# RENOVATION OF GALEHOUSE (A BUILDING), MCLEOD (S BUILDING), AND NATURAL SCIENCES (N BUILDING)

Cape Fear Community College Wilmington, North Carolina SCO #17-18154-01A; NCCCS #2352 BMG Project No. 2018023.00

#### **ADDENDUM NO. 1**

**ALTERNATE 1 FIRST** FLOOR DEMOLITION PLAN

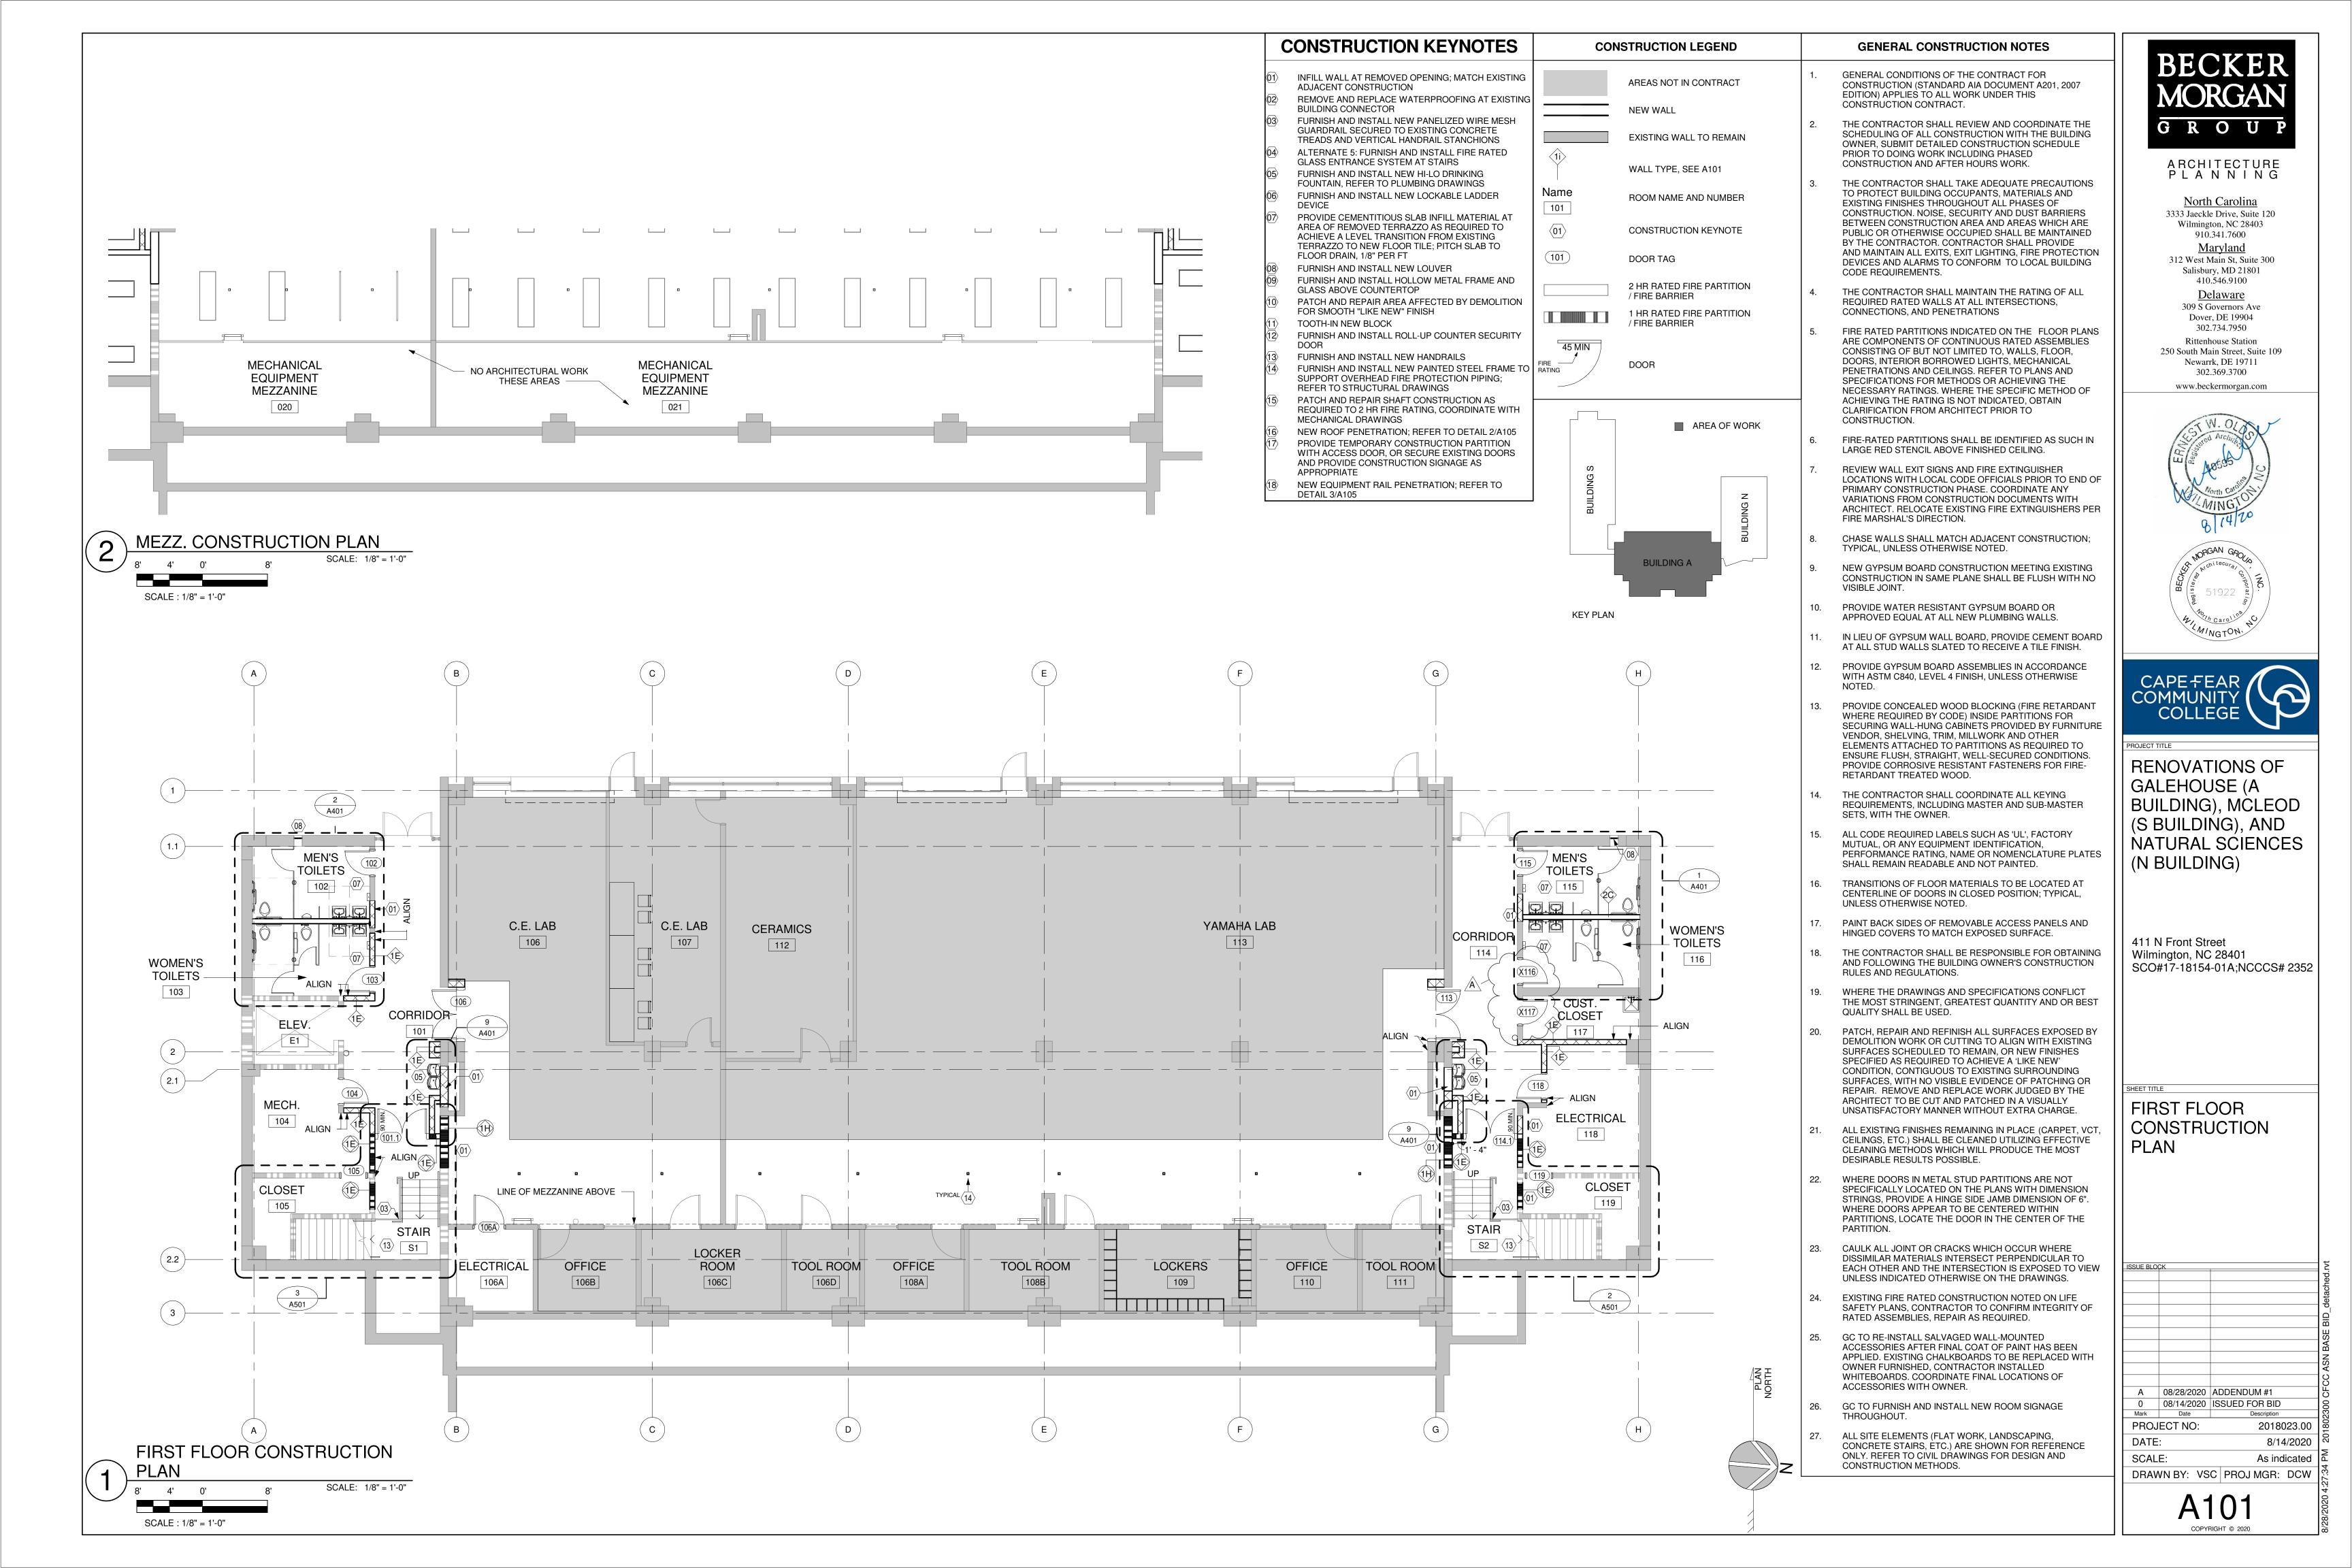
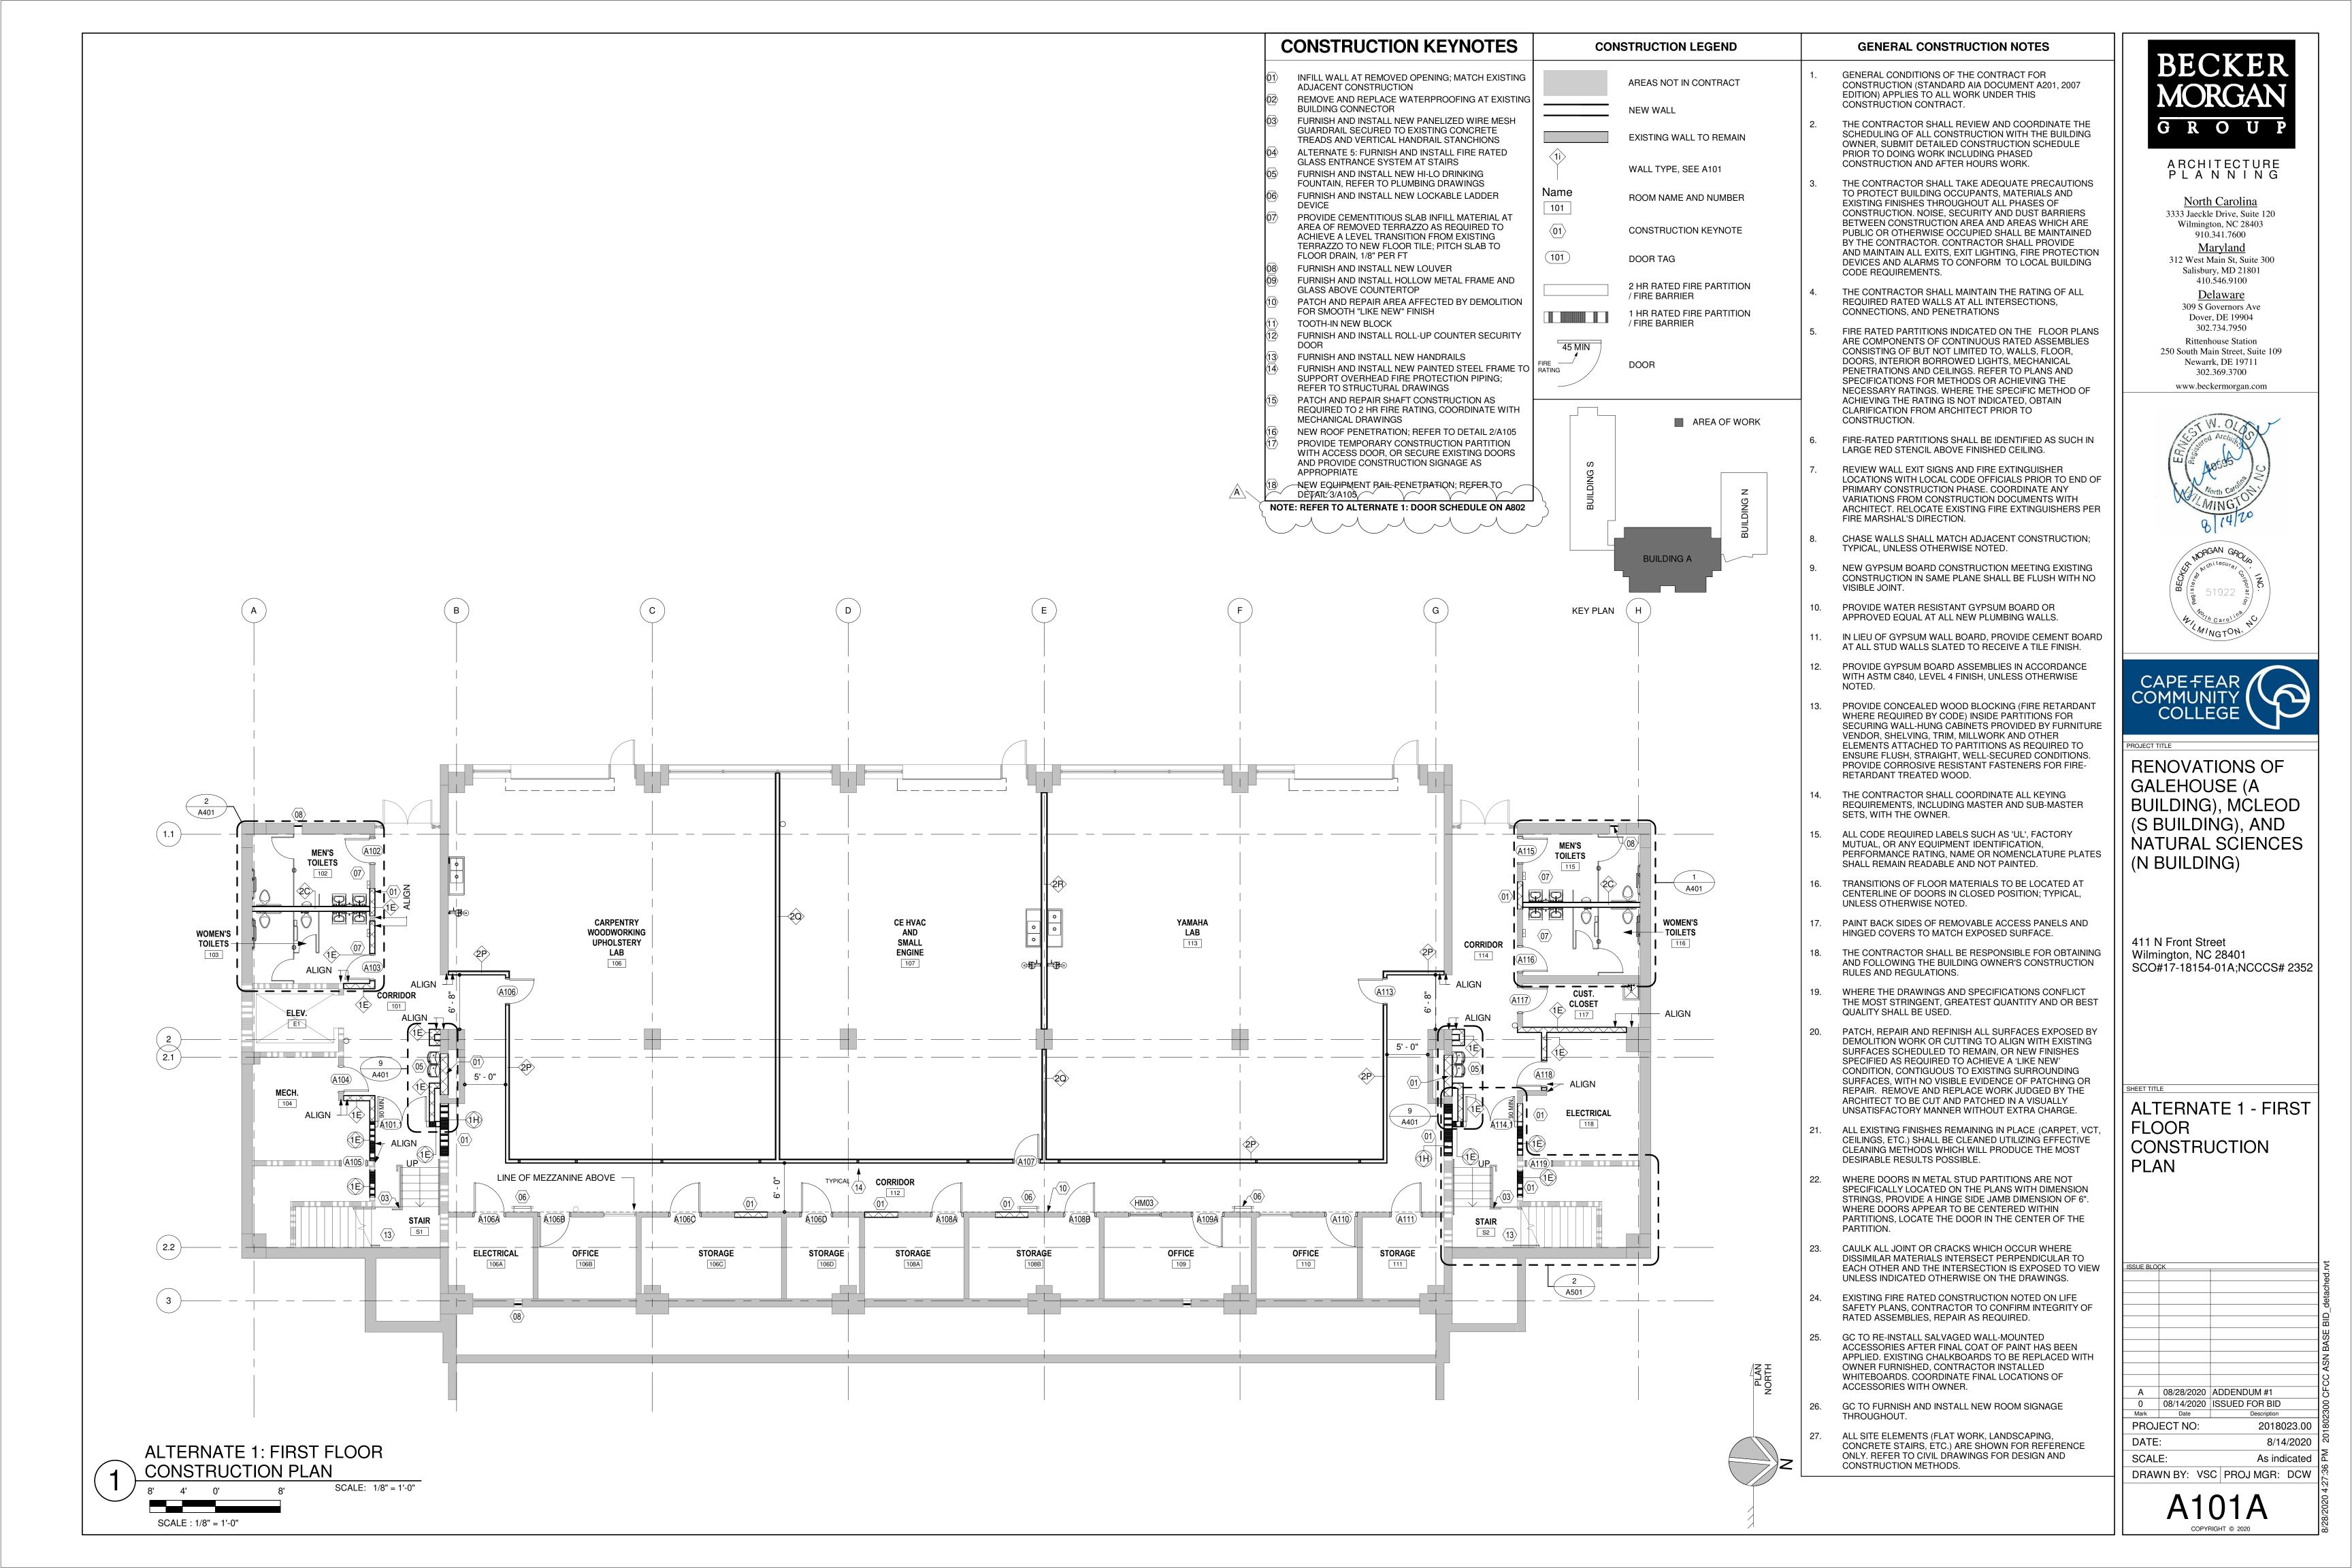
- b. AD101 FIRST FLOOR DEMOLITION PLAN: REVISED. Door shown to be demolished.
- c. A101 FIRST FLOOR CONSTRUCTION PLAN: REVISED. Door tags added.
- d. A101A ALTERNATE 1 FIRST FLOOR CONSTRUCTION PLAN: REVISED. Note regarding alternate doors added.
